## OFFICIAL COORDINATION REQUEST FOR NON-ROUTINE OPERATIONS AND MAINTENANCE

**COORDINATION TITLE- 23BON024 MOC Old Navlock dredge placement**

**PROJECT- Bonneville Lock and Dam**

**Figure 1-2 BON Dam NL1 Maint Dredge Project revised proposed placement site at Columbia Flowlane at RM 141 (avoids sediment loading of Chum spawning areas in the Ives-Perce complex).**

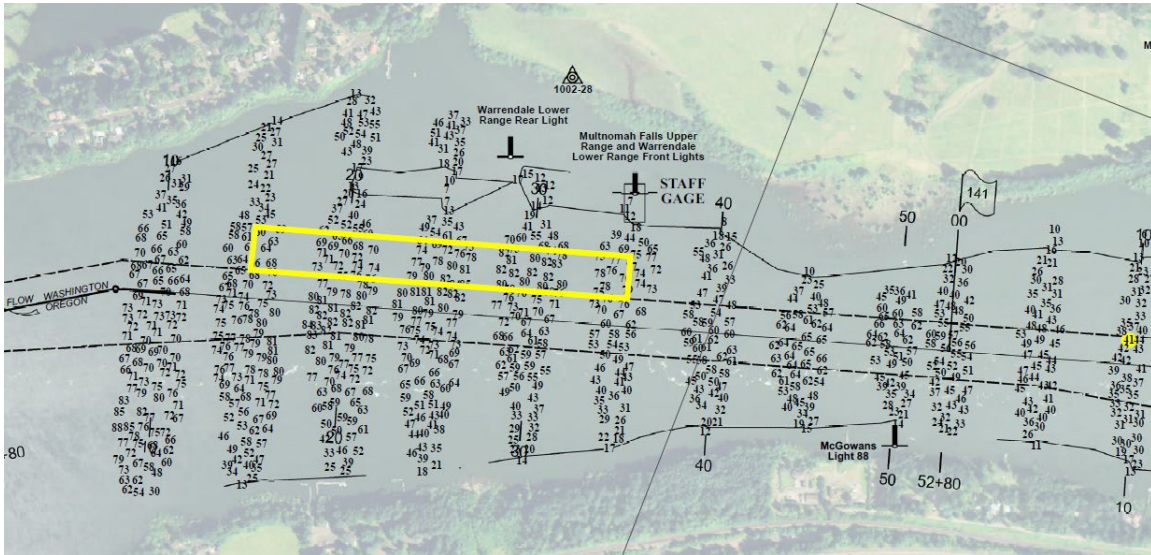
The MOC does not describe how the dredge material will be dispersed at  
RKM 144 (Near Hamilton Island) so that it will not negatively impact  
incubating chum fry in that area. Do you have any more information that  
indicates there will not be any existing redds near the deposition  
site, and any fry in redds near or downstream of the deposition site  
will not be impacted by sediment deposition? Please update the MOC to  
include this information. Thanks

Do you have a map that shows the specific dredge placement location at  
RM 144?

Slide 1 of the attached set shows three Chum spawning areas downstream, with 2 of them being in very close proximity. Could we set up a conversation with the appropriate entities to discuss the possibility of moving the release site ~2.5 miles downstream? I'm not the expert or the authority on this site but I can help prepare a reasonable alternative.

WDFW opposes disposal of dredge materials at RM 144 to avoid the possibility of any added silt to spawning areas in the Ives-Perce complex that could degrade currently available and utilized spawning sites for the listed Chum salmon population. The lower site poses less risk but does not totally alleviate risks to areas of suitable spawning habitat below RM 141.

I do not have specific dredge placement location.

My understanding with the PDT is they were remaining flexible with exact depo location as to be in line with any forthcoming guidance.

CR Flowlane @RM 144 was all I was going with for my in-process ODEQ water quality cert application as well.

I reached out to USACE dredge contract mgr. yesterday with info on potential fish spawning habitat near RM144, as a heads up for possible relocation.

Nathan sent me link to WDFW PHS mapper and I ran the attached with the proposed depo site and 100m radius if this helps.

From: Morrill, Charles (DFW) <Charles.Morrill@dfw.wa.gov>  
Sent: Tuesday, November 21, 2023 10:17 AM  
To: Mackey, Tammy M CIV USARMY CENWP (USA)  
Subject: [Non-DoD Source] RE: FPOM: Official Coordination - 23BON024  
MOC - final comments due 30 Novomer  
Thanks Tammy,  
Our concerns have been addressed in the updated MOC.  
Happy Gobble Gobble Day and weekend 😊  
Charlie

Thank you to the Corps for addressing our concerns, we have no further comments on this MOC. Happy Thanksgiving, hope you and your family enjoy all of your baked treats!
